March 6, 2023

Colorado Department of Natural Resources
Division of Reclamation, Mining and Safety
ATTN: Patrick Lennberg
1313 Sherman Street; Room 215
Denver Colorado 80203

RE: Adequacy Review No. 1; Technical Revision (TR-1) – Revise Mining and Reclamation Plans and Maps to Account for Acreage Release Areas in AR-1; Irwin/Thomas Mine, Permit No. M-2016- 054

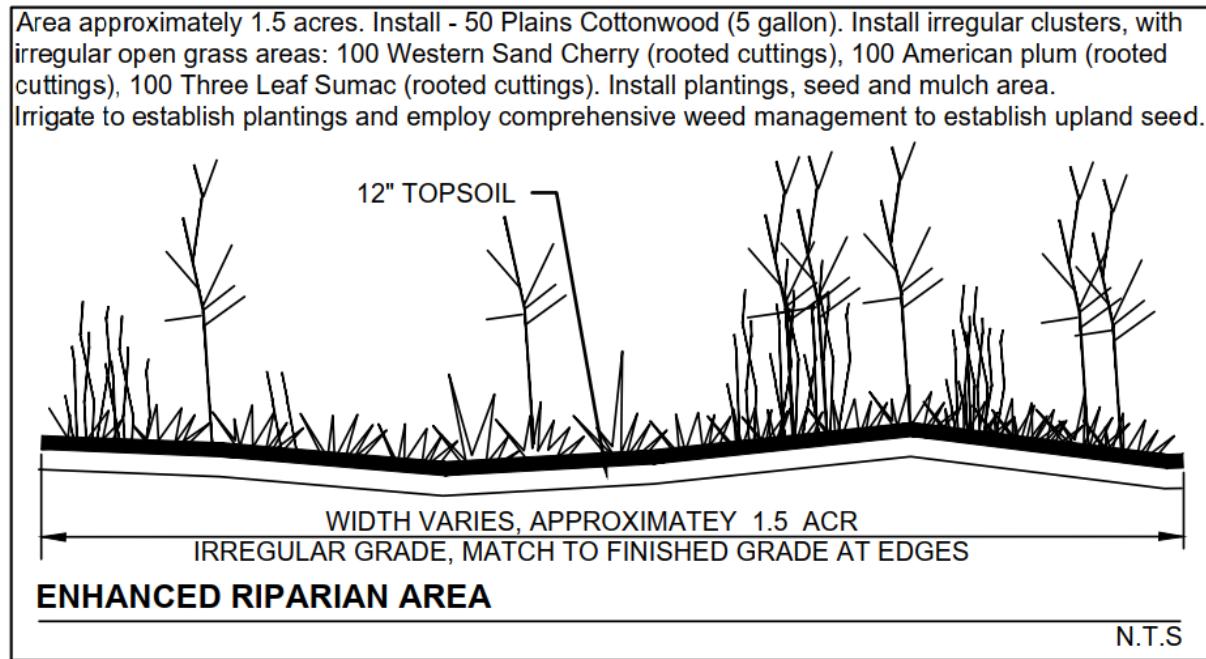
10. In the Operator's responses, dated July 20, 2017, to the Division's Adequacy Review No. 2 item #8 the Operator states, *Initial information provided to the Division that a City of Longmont Special Use Permit was being obtained for the project was not accurate. The project will be constructed in the City of Longmont under a PUD Development Plan. When obtained following completion of annexation, a copy of the approved City of Longmont PUD Development Plan will be provided to the Division in the form of a technical revision.* Please provide an update or a copy of the PUD Development Plan.

Applicant Response: A copy of the City of Longmont Final Development Plan (FDP) is included as Attachment I. We are working with the City of Longmont on a process to bring the FDP into alignment with the Technical Revision. Once the Technical Revision is complete, we will process a Site Plan Waiver Application to bring the FDP into alignment with the updated mining sequence as depicted in the Technical Revision. We will forward the updated FDP to the Division upon completion of the Site Plan Waiver process.

RECLAMATION PLAN

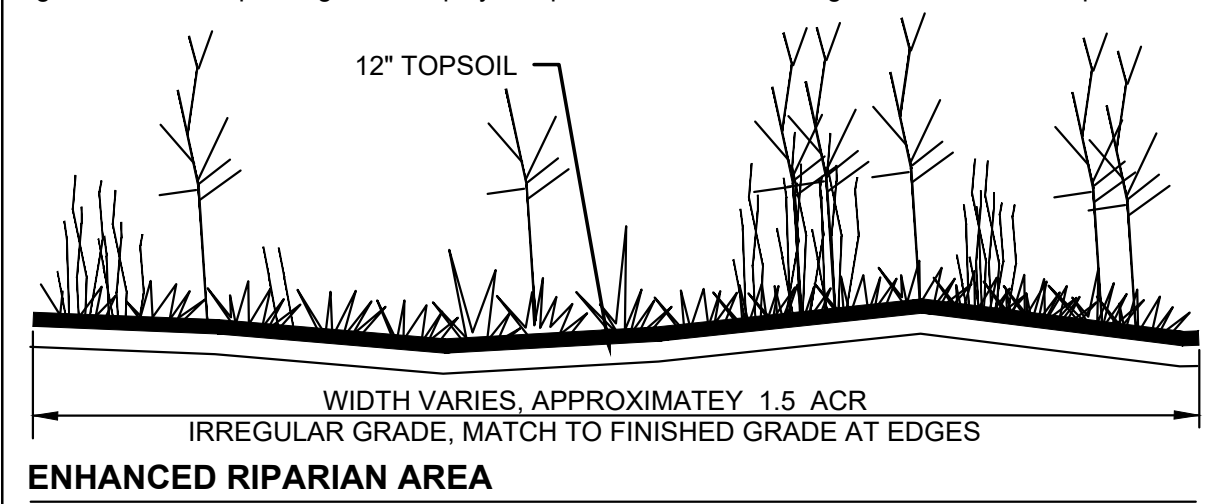
11. Please provide the details on the proposed enhanced riparian area adjacent located in Mining Area 1 and adjacent to St. Vrain Greenway.

Applicant Response: The planting detail for the enhanced riparian area is included on Exhibit-F, Reclamation Plan map and shown below. The goal is to establish an irregular area with a combination of shrub thickets, overstory trees and open grasses to provide food and cover for wildlife. The original mining

Revised EXHIBIT C-5 Mining Plan Map

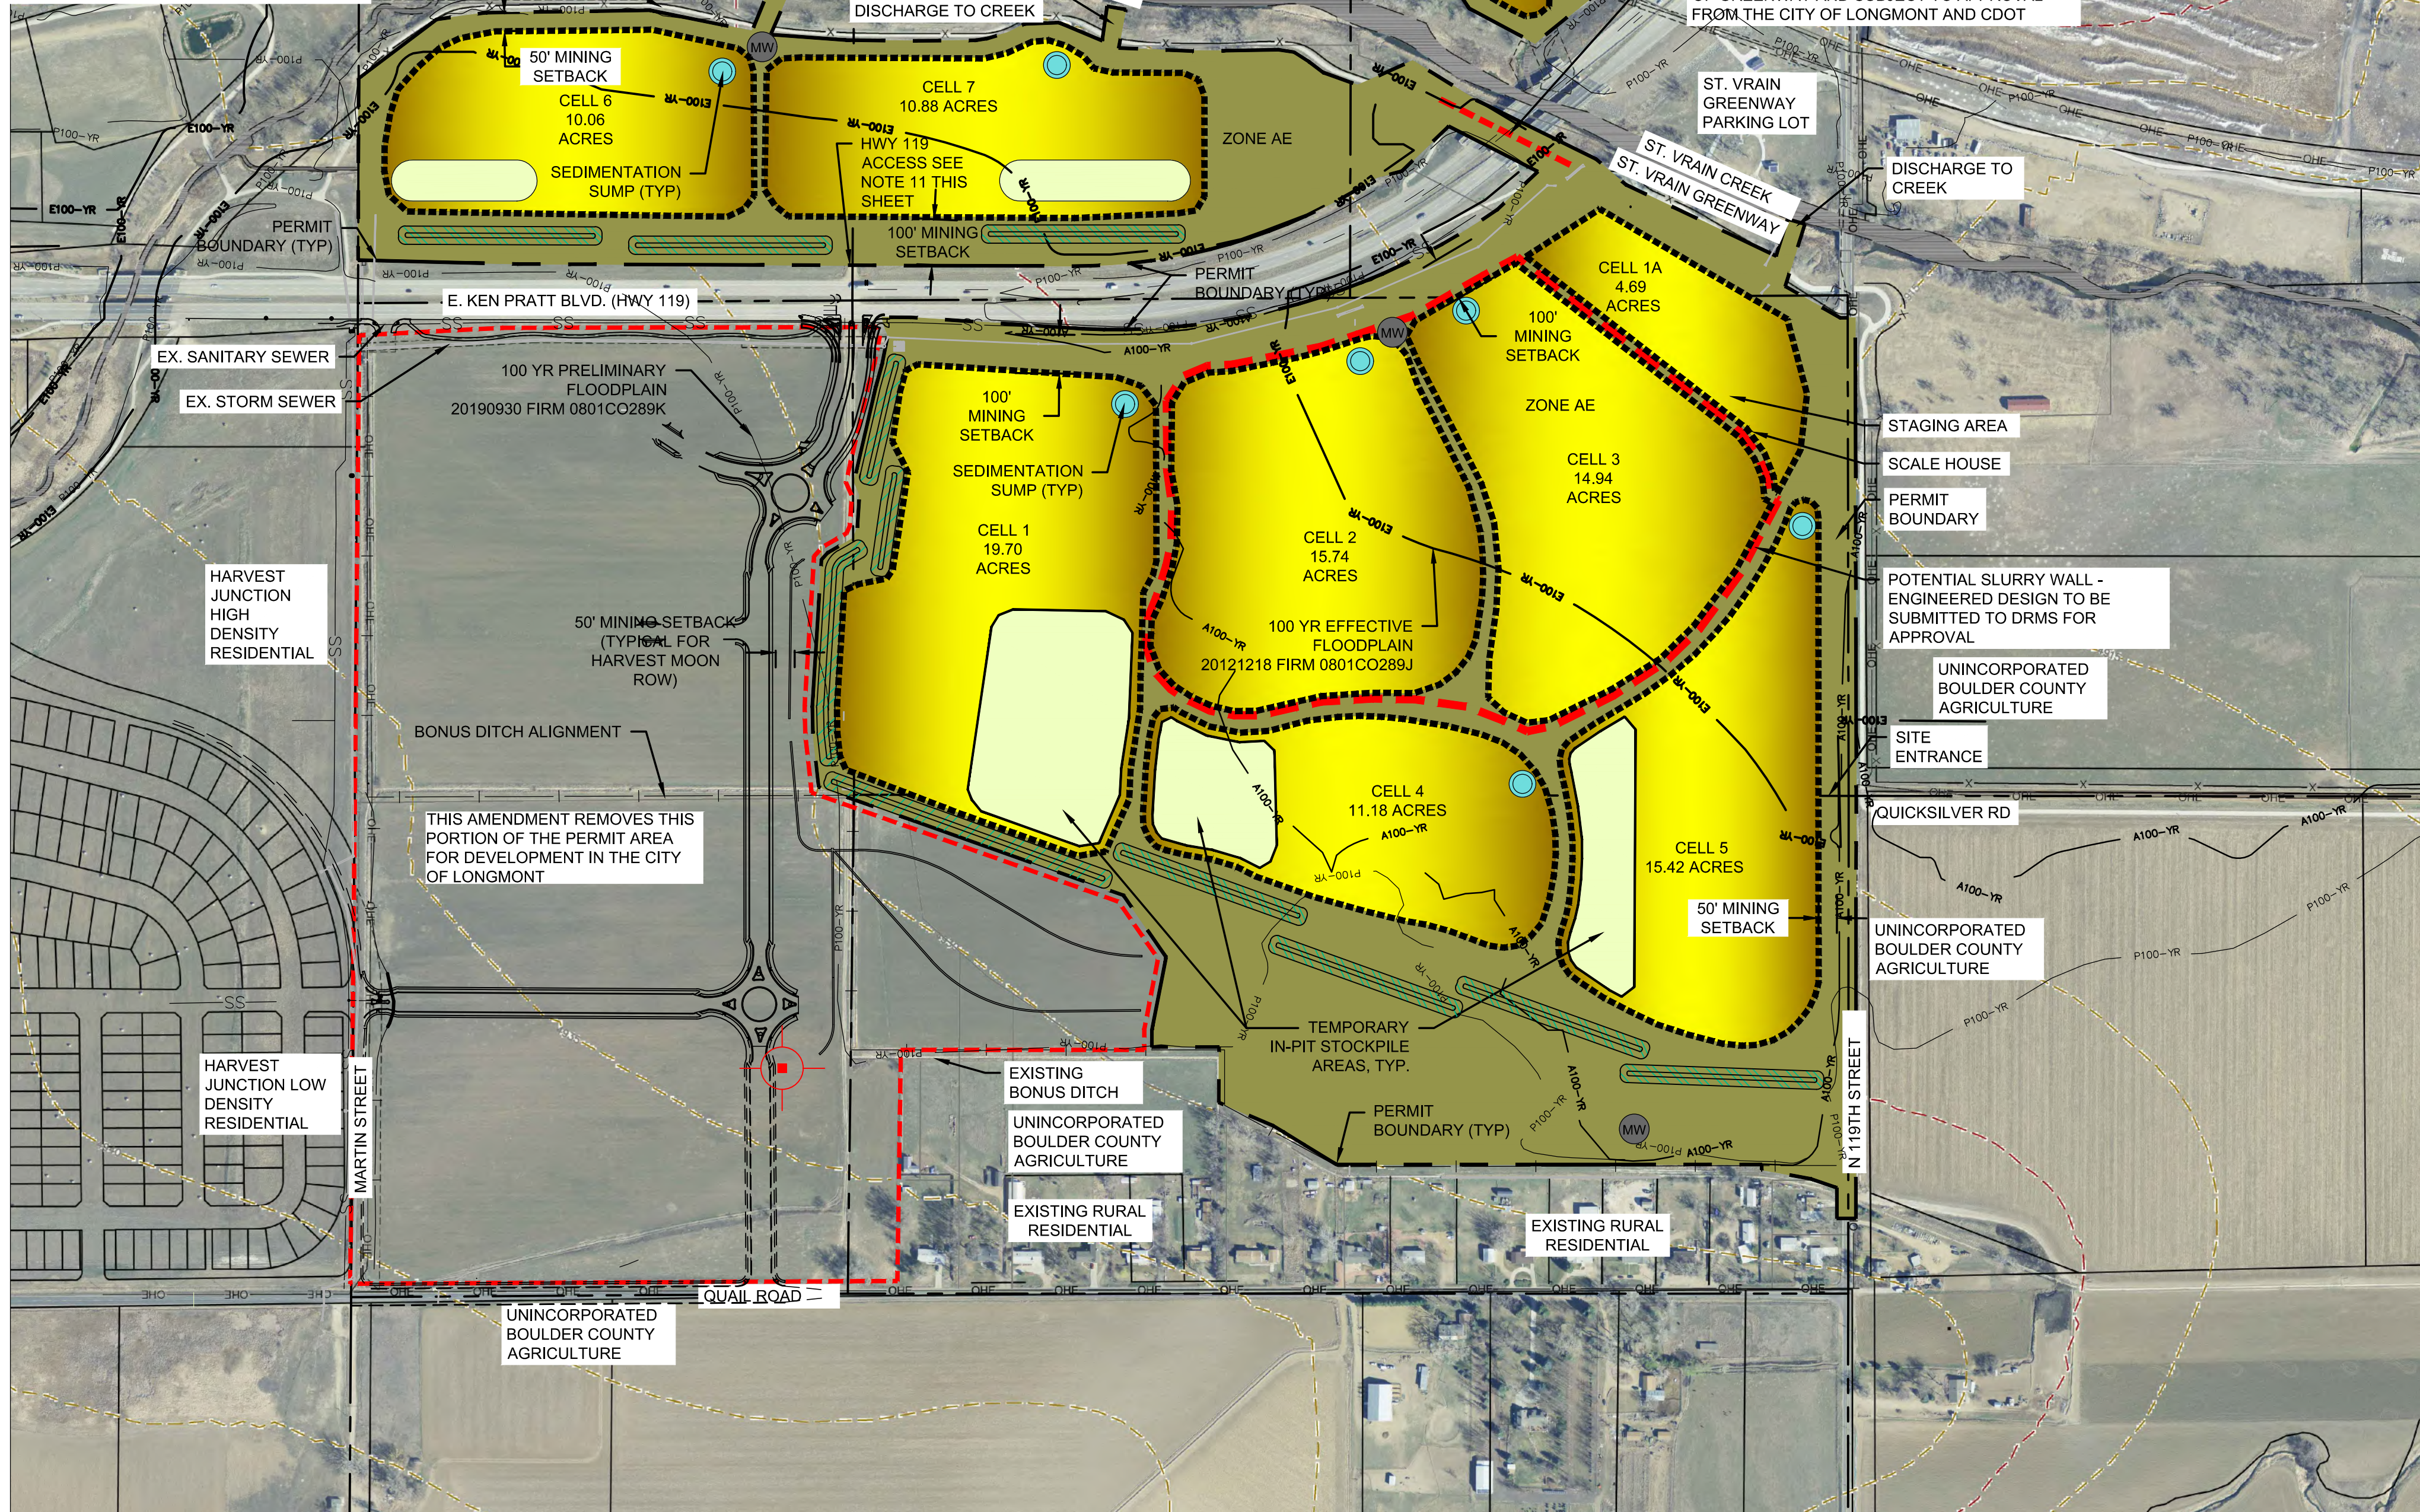
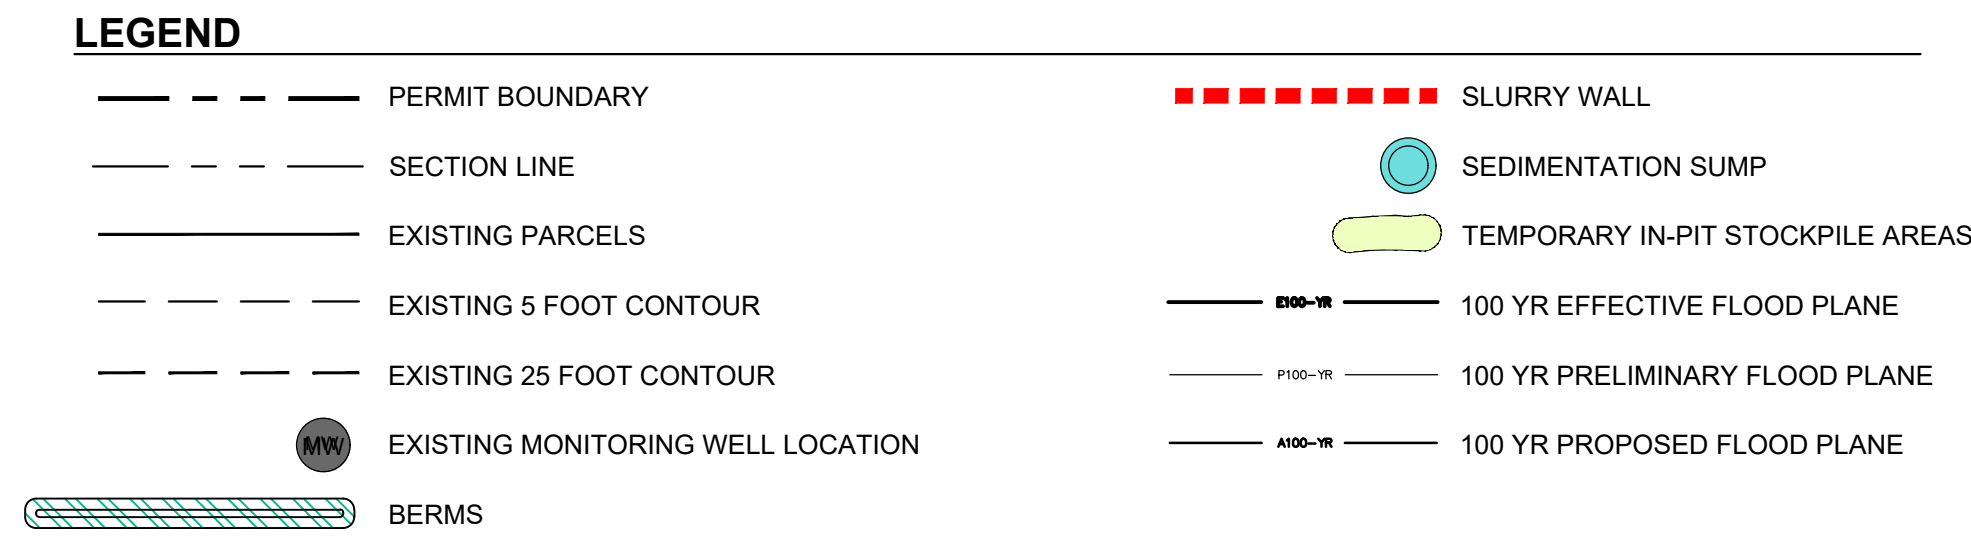
4. Please provide an updated Mining Plan Map C-5 include on the map the monitoring well locations that are measured monthly. Label the wells according to the annual submittals.

Applicant Response: An updated Exhibit C-5 Mining Plan Map is included as Attachment 5.
